October 3, 2011

September 19, 2011

Re: Lake DeTurk Dam Inspection

TRENCH DRAIN DETAIL

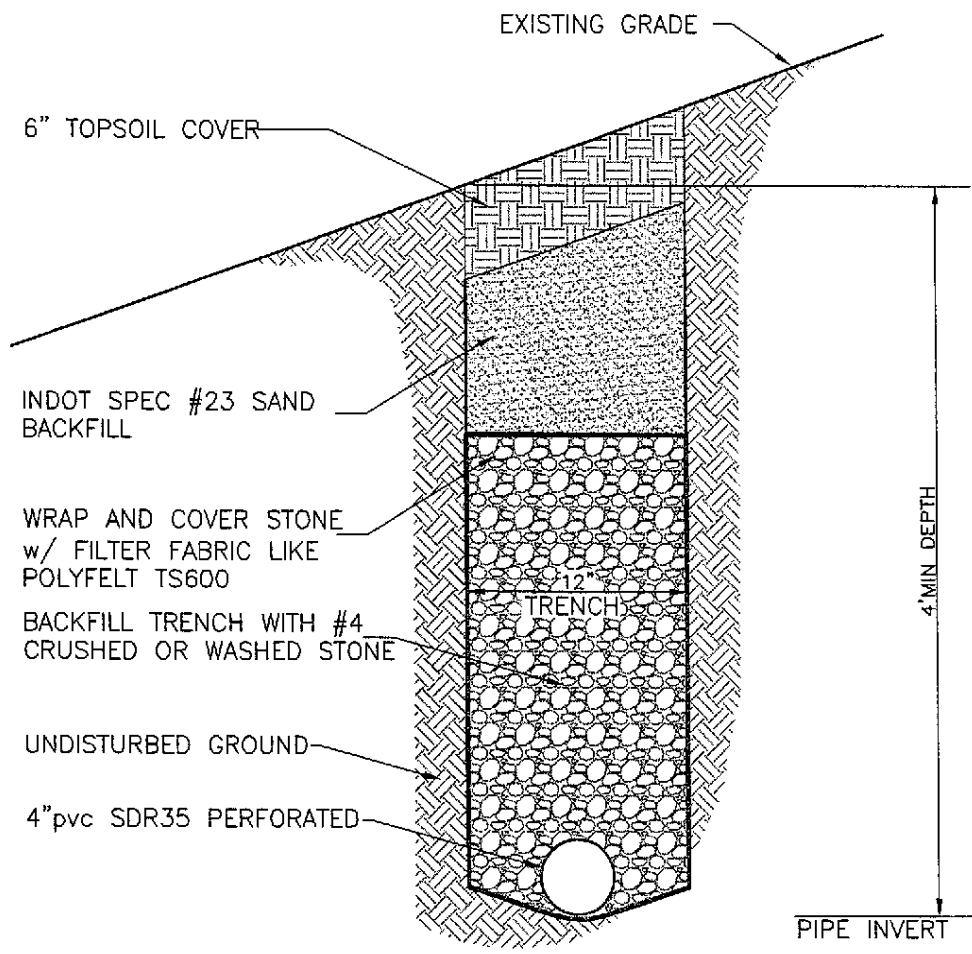
(D-10) The wet areas down slope of the spillway manhole were evaluated. It appears that the wetness may be from seepage along, or leakage of a nearby conduit. We would recommend the installation of a perforated drain tile above the wetness to a depth of about 4 feet to capture any flow. This will allow the surface to dry up. It will also facilitate observation of water quality and quantity exiting the drain. A drain tile detail is attached for reference.
